**COPLEY TOWNSHIP
SITE PLAN REVIEW
MAJOR SITE PLAN/VARIANCE
1330 S CLEVELAND MASSILLON RD
STAFF REPORT**

PROJECT: Autobahn Service Center	
PPN: 1508677	APPLICATION TYPE: Major Site Plan/Variance
LANDOWNER	Copley Holdings LLC
APPLICANTS	David W Smith, Architect LLC
COMPANY PERFORMING WORK REQUESTED	Weber Engineering
INVESTMENT	\$1,400,000
APPLICATION SUMMARY	<i>Applicant, David W Smith, on behalf of Autobahn Service Center, is requesting Site Plan and variance approvals for a commercial addition and parking lot improvements.</i>
INITIATED BY	Applicant
DECISION TYPE	<input type="checkbox"/> Informational <input type="checkbox"/> Direction <input checked="" type="checkbox"/> Action
CODE REFERENCES	Section 5.01-I Industrial Sections- 9.06 5., 8 a., 9. Parking Construction, Wheel stops & Setbacks Section 13.01 F-Site Plan Review Article 14-Landscaping, Buffering and Screening
GENERAL LOCATION	The parcel is located on the corner of Sunset Drive and S Cleveland Massillon Road
LAND AREA	1.8 Acres
ZONING	Industrial (I)

ELEVATIONS

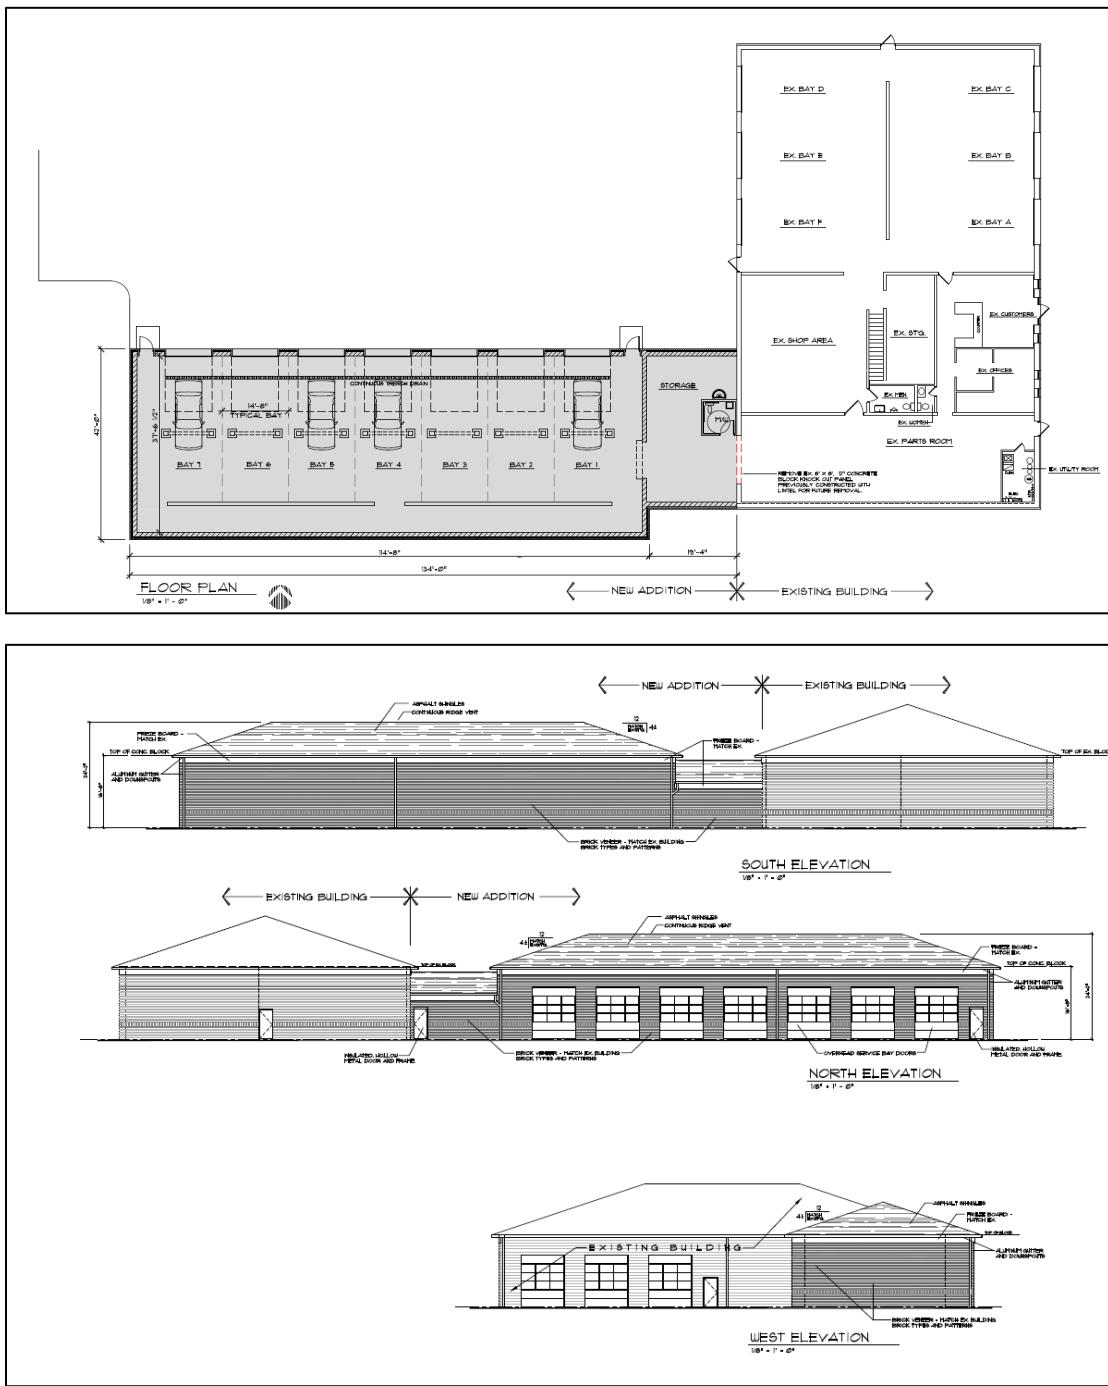
- 25' Minimum Front Yard Setback
 - Proposed Setback-Sunset Drive-60+'
 - Proposed Setback-S Cleveland Massillon Rd-60'
- 25' Minimum Rear Yard Setback: West
 - Proposed Setback-25'
- 25' Minimum Side Yard Setback
 - Proposed Setback- South: 18'
 - On 6/5/1991, A variance was granted for the reduction in the side yard setback from 25' to 15'
- 50' Maximum Building Height: The structure will be consistent in height with the existing structure. The structures do not exceed 25' in overall height

PARKING STANDARDS-Variance Required

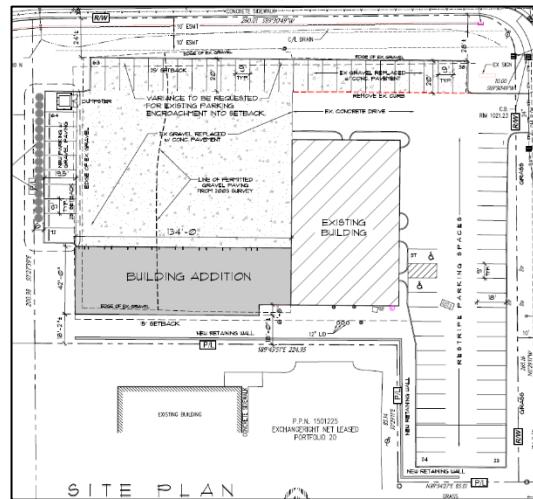
The applicant plans to reconfigure the existing parking lot which will result in a reduction of 9 parking spaces and an increase of 1,600 square feet of new impervious surface for the proposed lot along the western side yard property line.

- Existing parking
 - 81 spaces
- Permitted parking
 - 72 spaces per Copley Township Board of Trustees development agreement for Sunset Drive
- Proposed parking
 - 72 spaces
 - Recommend removal of space 1

VARIANCE 1: Reduction in the required parking setback (Sunset Drive)

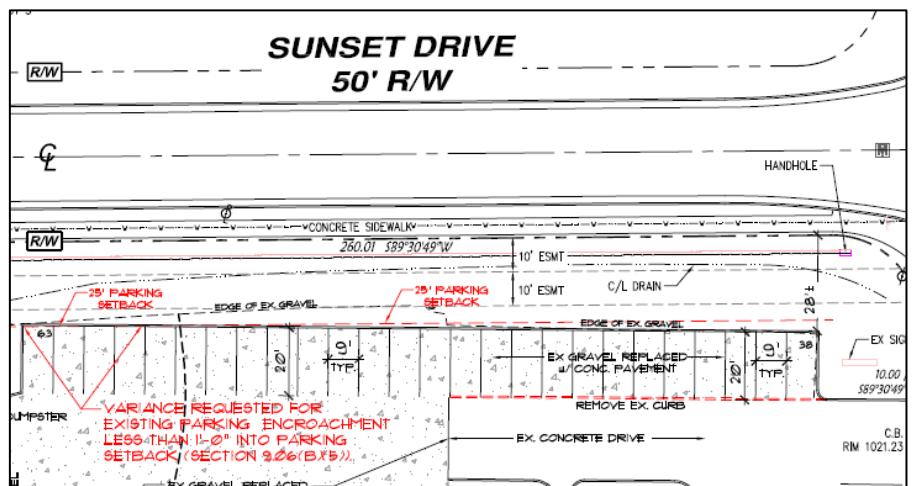
Per Article 9, Section 9.06, 5.

Yard Requirements. Subject to the limitations of Section 9.06 B. 2. a., off-street parking spaces may occupy all or any part of any required side or rear yard. However, in no event, shall any required front yard or the side yard along the side street in the case of a corner lot be occupied by such parking space.

Request: Variance to encroach into the 25' front yard setback by 1'

VARIANCE 3: Wheelstops

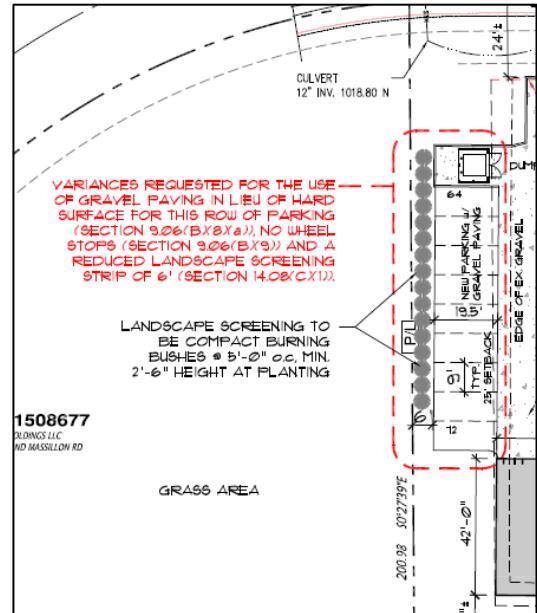
Per Article 9, Section 9.06 9. Wheel Stops. Whenever a non-residential parking area extends to a lot line, sidewalk, planter strip or building, a wheel stop device consisting of blocks, a permanent curb, expanded sidewalk or other suitable restraint shall be installed. The minimum height of a wheel stop device shall be five (5) inches and the minimum distance from a wheel stop device to a property line or protected area shall be two (2) feet six (6) inches.

Request: Relief from section 9.06 9. No wheel stops
